XRAY T2

#302661 CLOSED BALL JOINT 5MM

REAR
#302653

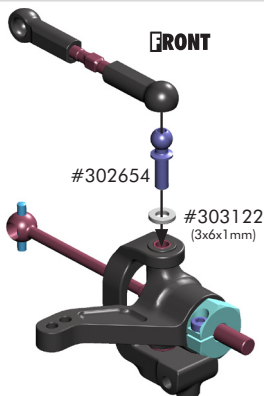
The closed ball joint prevents dust from getting onto the ball end, allowing the upper camber links to move more freely.

The new closed ball joints must be used with the new ball ends. However, the new ball ends are designed to be used with standard open ball joints as well.

The new ball ends are a direct replacement for the standard balls and were designed to keep the same geometry; no re-adjustments are necessary.

The number of shims should be the same as are used with standard ball joints.
